ECE/TRANS/WP.29/GRPE/2014/4/Rev.1

Retrofit Emission Control Devices (REC)

Updated Proposal for the 01 series of amendments to the UN Regulation on uniform provisions concerning the approval of Retrofit Emission Control devices for heavy duty vehicles

Submitted by the Chair of the informal working group on Retrofit Emission Control devices (REC)*

Arrangement of the REC ~~System~~ Type-Approval mark

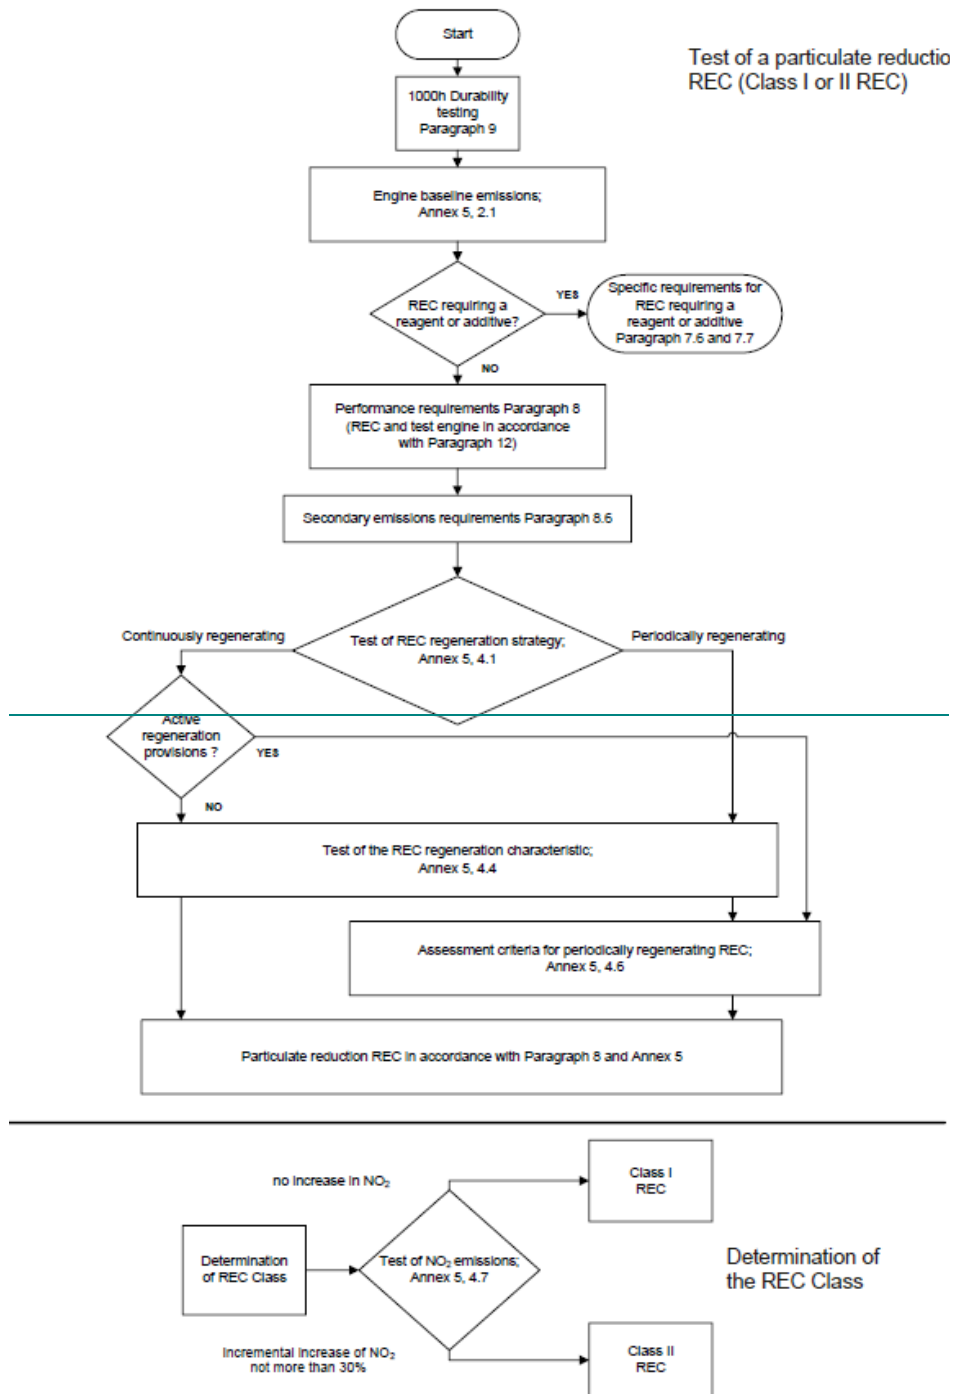
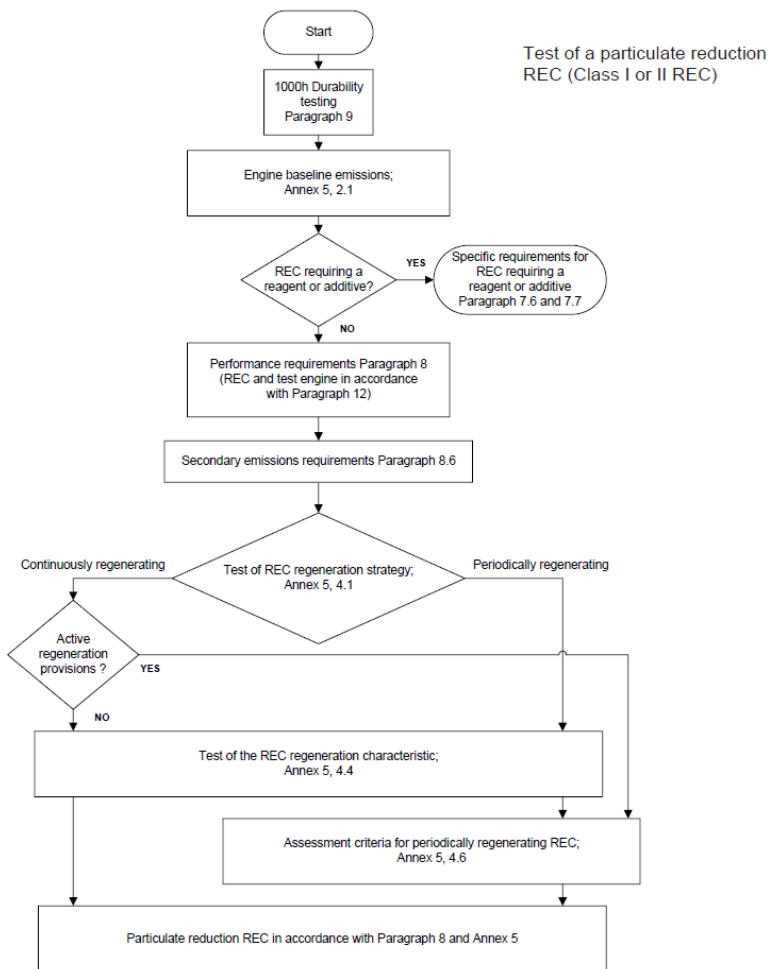
Annex 4, amend to read:

The above example type-approval mark affixed to a REC shows that the type concerned has been approved in the Netherlands (E4), pursuant to Regulation No. [nnn] under type-approval No. 001234. The first two digits of the type-approval number indicate that the approval was granted in accordance with the requirements of Regulation No. [nnn] in ~~its original~~ the form amended by this series. The approval mark shall also show the Class of REC (I, IIA, IIB, III or IV)."

Test sequences

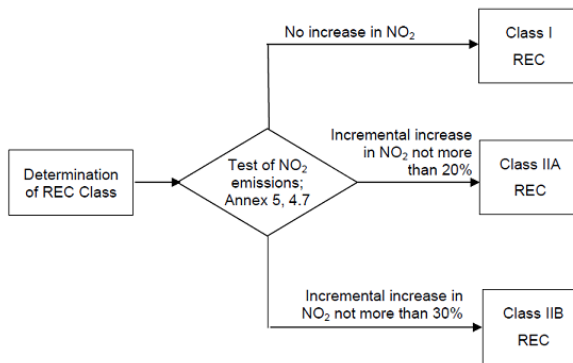
Annex 8, amend to read:

Determination of the REC Class
